FLIGHT CONTROLS - INSTALLATION OF THE HORIZONTAL STABILIZER TRIM POSITION SENSOR AND SPLINE SHAFT ENGAGEMENT HARDWARE

MODEL	SERIAL NUMBERS
750 (Citation X)	-0001 thru -0313
750 (Citation X+)	-0501 thru -0532

To install a new horizontal stabilizer trim position sensor and spline shaft engagement hardware.

SB750-27-69
Page 1 of 9

Figure 1. Installation of Sensor and Spline Shaft Engagement Hardware (Sheet 1)

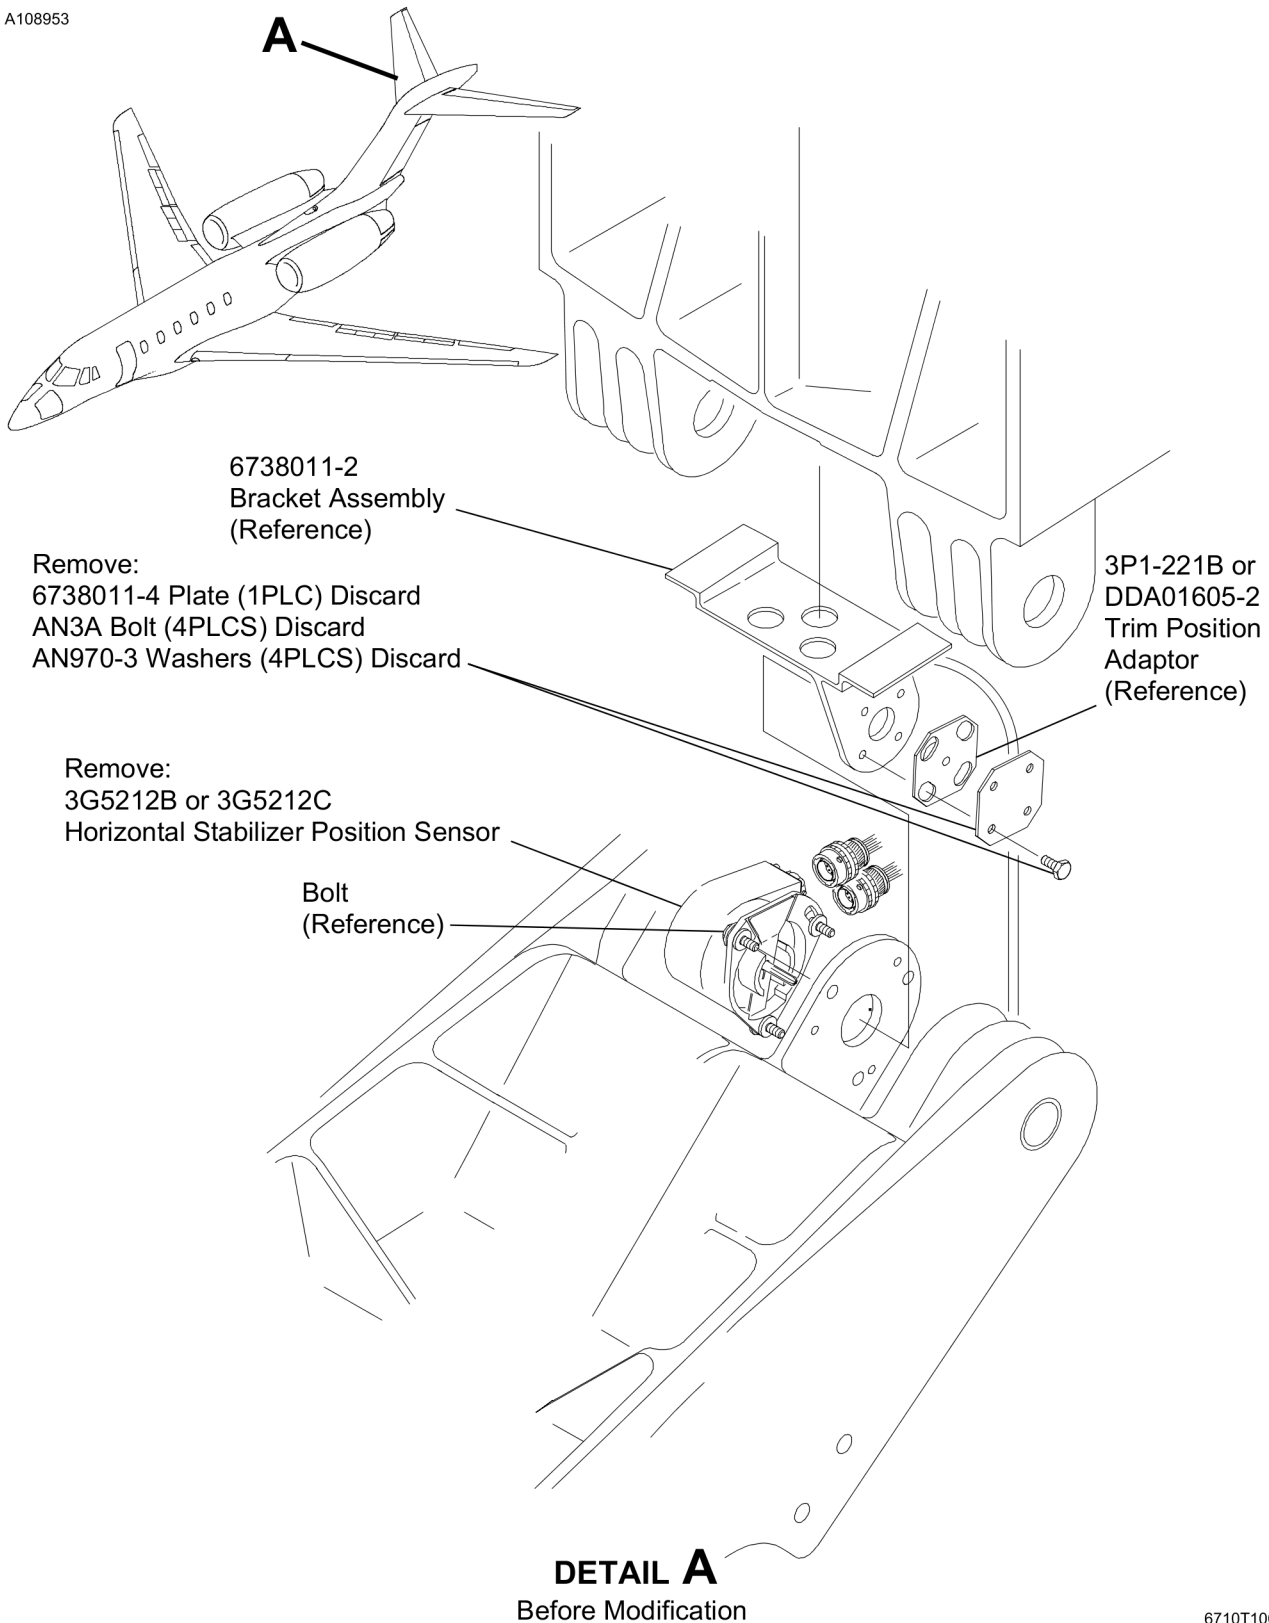
2. (Refer to Figure 1, Sheets 1 and 2.) On aircraft 750-0001 thru 750-0500, do the steps that follow:
 - A. Remove the 3G5212B or 3G5212C Stabilizer Trim Position Sensor (UV001) and keep the mounting hardware. (Refer to Cessna Model 750 (0001-0500) Maintenance Manual, Chapter 27, Horizontal Stabilizer Trim System - Maintenance Practices.)

- B. Install the 3G5212D Stabilizer Trim Position Sensor (UV001) using the kept mounting hardware. (Refer to Cessna Model 750 (0001-0500) Maintenance Manual, Chapter 27, Horizontal Stabilizer Trim System - Maintenance Practices.)

NOTE: Leave the Horizontal Stabilizer Centering tool installed until the horizontal stabilizer trim position sensor installation is complete.
4. (Refer to Figure 1, Sheets 1 and 2.) Install the horizontal stabilizer trim position sensor RVDT spline engagement hardware as follows:
 - A. Remove the four bolts and washers that attach the 6738011-4 (750-0001 thru -0500) or 6738011-5 (750-0501 thru -0532) plate to the 3P1-221B Adapter. Discard the bolts and plate.
 - B. Install one 6793042-205 Locator into the existing 3P1-221B or DDA01605-2 Adapter.

NOTE: Make sure during the installation of the 6793042-205 Locator the 3P1-221B or DDA01605-2 Adapter does not move and stays engaged with the aircraft structure and RVDT spline shaft.
 - C. Install one 6793042-202 Pin Weldment through the hole of the 6793042-205. Make sure the 6793042-202 Pin Weldment engages into the spline shaft of the RVDT.
 - D. Install one 6793042-206 plate over the 6793042-202 Pin Weldment.
 - E. Turn the 6793042-204 Plate and 6793042-205 Locator as necessary to align the parts with the necessary fastener holes in the aircraft structure.

NOTE: Make sure the existing 3P1-221B or DDA01605-2 Adapter stays centered and engaged on the RVDT spline shaft.
 - F. Attach the 6793042-204 Plate, 6793042-205 Locator and the existing 3P1-221B or DDA01605-2 Adapter using four NAS6203-3 Bolts and four AN970-3 Washers.
 - G. Torque the bolts to 15.0 to 20.0 inch pounds (1.69 to 2.25 Nm).

Figure 1. Installation of Sensor and Spline Shaft Engagement Hardware (Sheet 2)

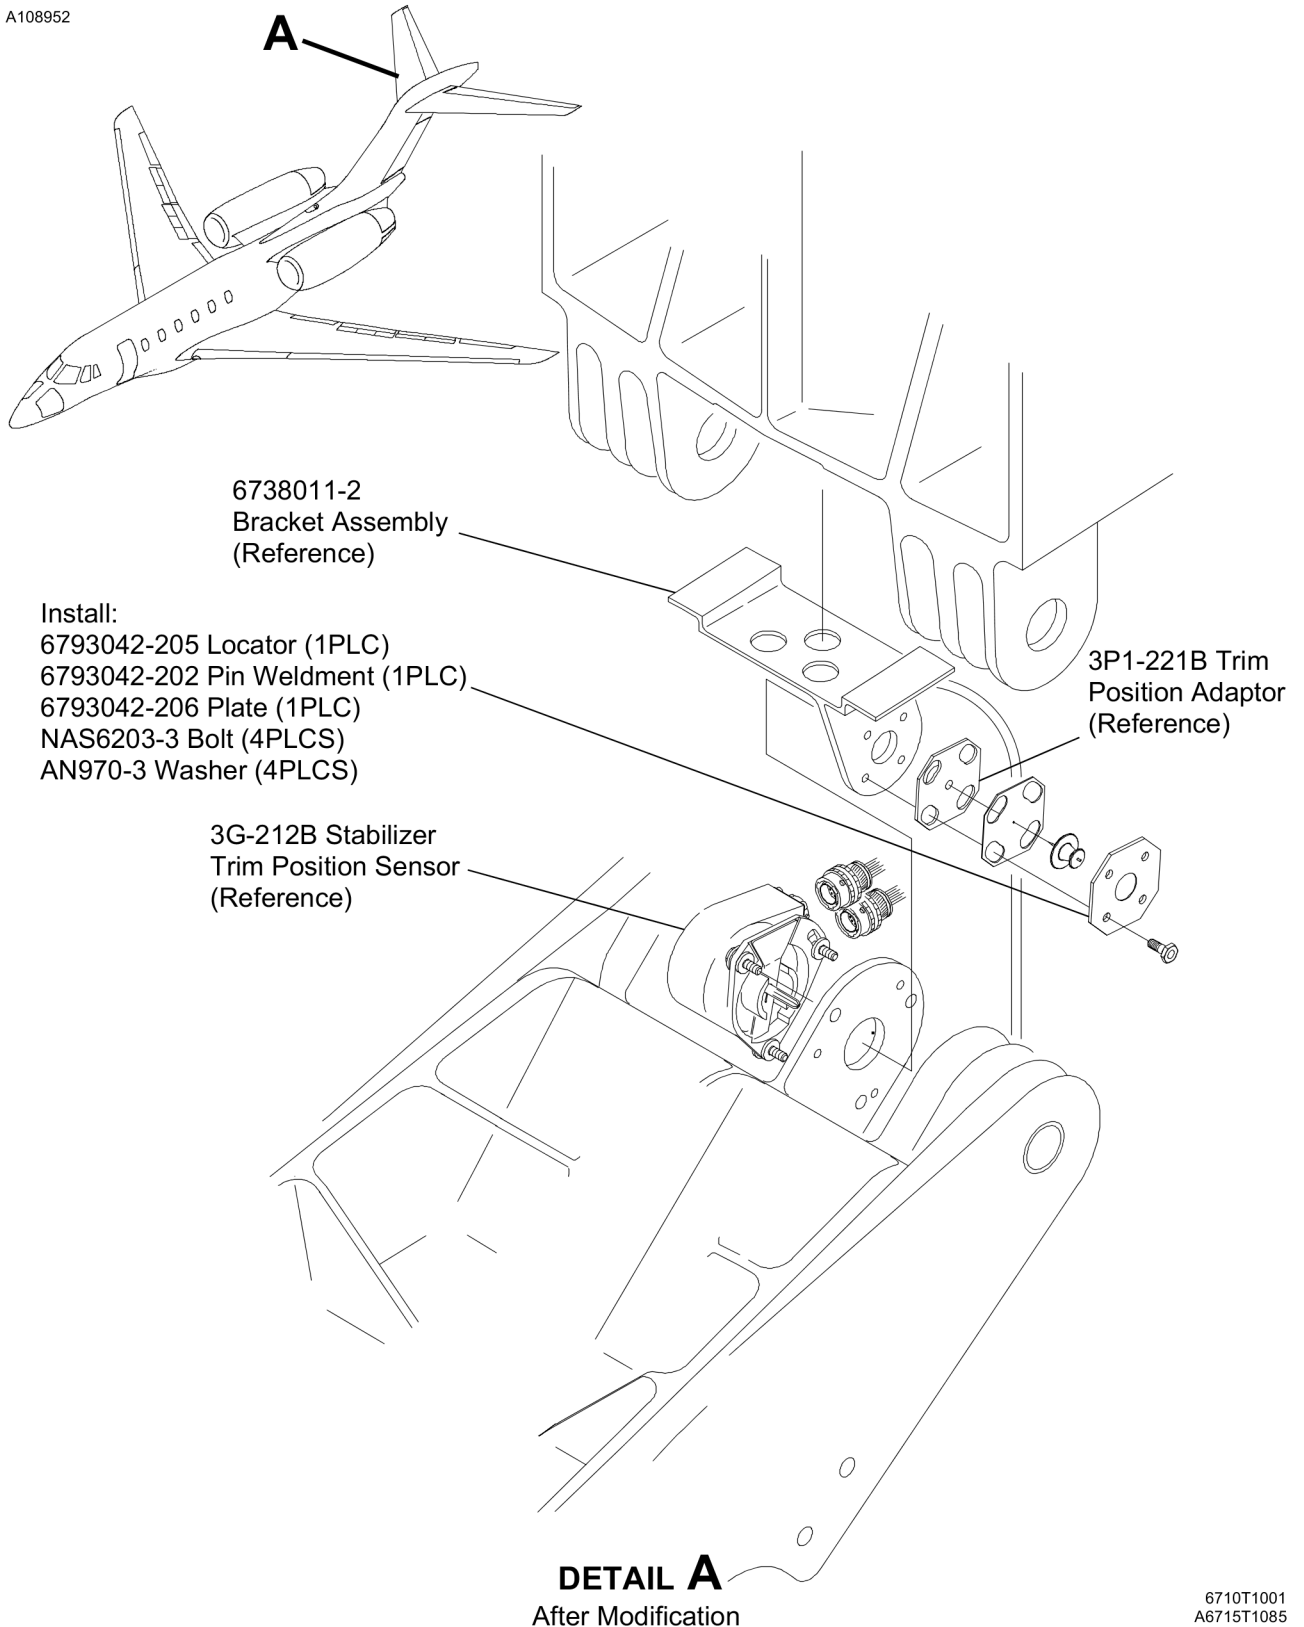
NOTE: Tighten the bolts equally to make sure the spline shaft stays straight within the adapter.
5. On aircraft 750-0001 thru 750-0500, do the steps that follow:

Figure 2. Inclinometer Installation Location on the Horizontal Stabilizer (Sheet 1)

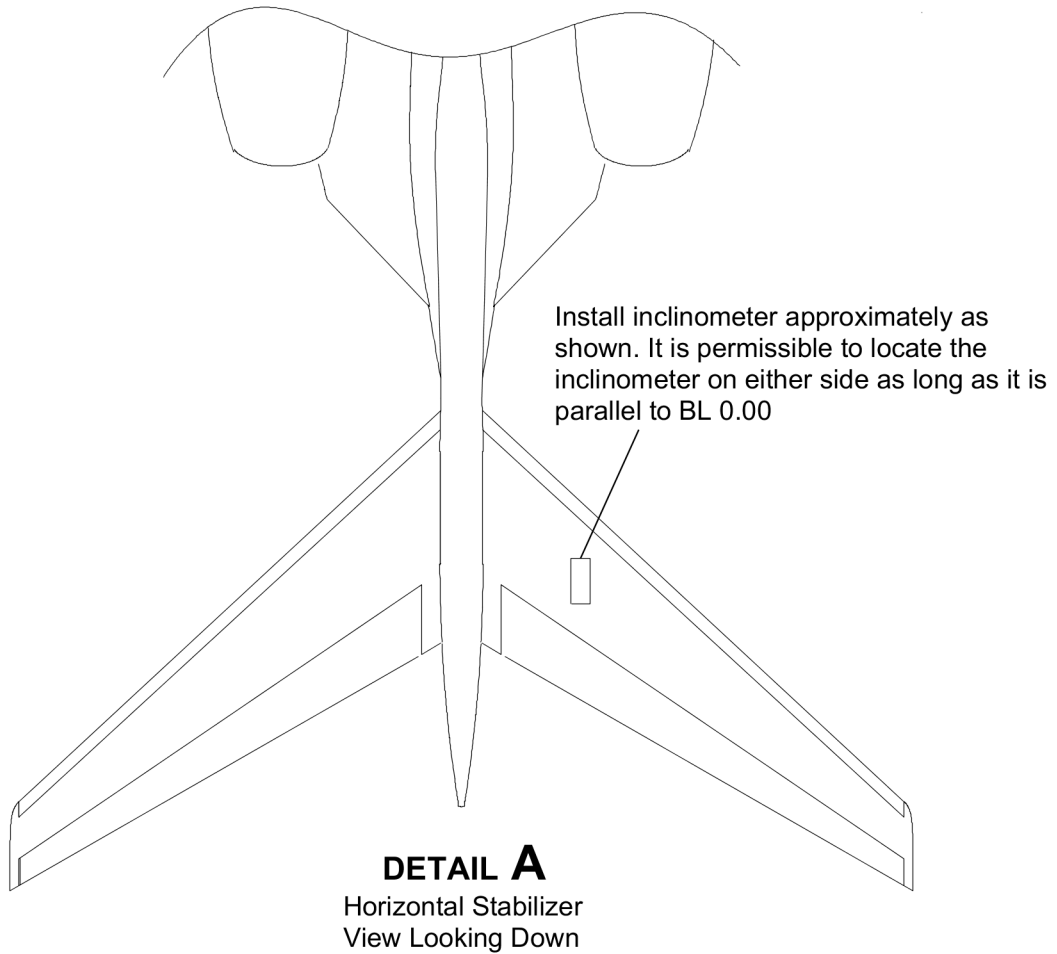
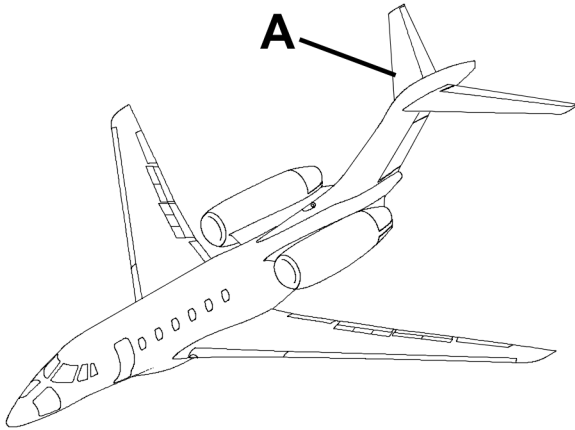
- D. Turn the avionics switches to the ON position.
 - E. (Refer to Figure 2, Sheet 1.) Install an inclinometer on the horizontal stabilizer.
 - F. Do the horizontal stabilizer trim check as follows:

- (b) Make sure the EICAS shows 1.2 (\pm 0.3) degrees.
 - (c) Make sure the EICAS position indication is not amber.
 - (3) (Refer to Figure 2, Sheet 1.) Remove the inclinometer from the horizontal stabilizer.
